802.3cu D1p0  
proposed editing to 100GBASE-FR1/LR1 and  
400GBASE-FR4/LR4 PMDs.

- This presentation contains 802.3cu D1p0 considerations and proposed relative changes for 100GBASE-FR1/LR1 and 400GBASE-FR4/LR4 PMDs.
- Comments and proposed changes about:
  1. Delta between Average launch power (min), Outer Optical Modulation Amplitude (OMA<sub>outer</sub>) (min)
  2. Allocation for penalties (DGD penalties).
  3. Compatibility between 100GBASE-FR1 and 100GBASE-LR1.
  4. Average power of OFF transmitters.

Table 151–7—400GBASE-FR4 and 400GBASE-LR4 transmit characteristics

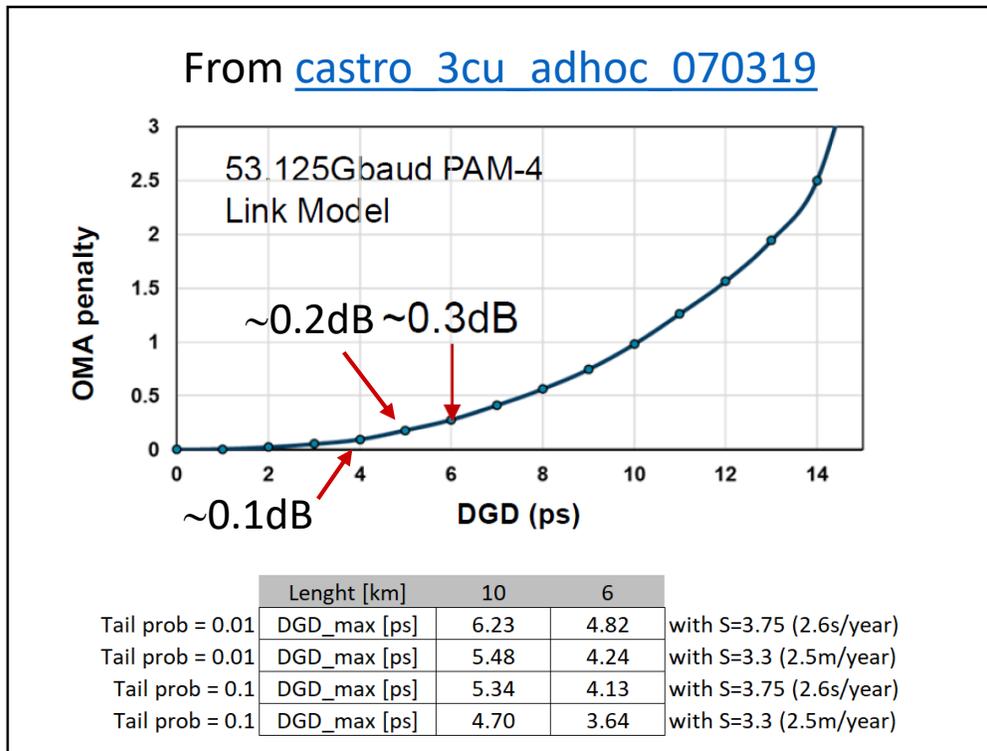
The difference between Average launch power (min) and Outer Optical Modulation Amplitude (OMA<sub>outer</sub>) (min) has been set to 3dB for 400GBASE-FR4 and 400GBASE-LR4 transmitters (equal to the delta considering infinite ER of the transmitter).

This is in line with other adopted PAM-4 PMD in previous standards (e.g. 50G-based PMD (200GBASE-FR4/LR4, 400GBASE-FR8/LR8)).

But this is not applied to 100GBASE-FR1 and 100GBASE-LR1, so in this way we unfairly penalize existing high ER (> 10dB) TXs.

*Note: also 100GBASE-DR too is affected, but is outside the scope of this project. 100GBASE-FR1 should not be reduced to a level below 100GBASE-DR.*
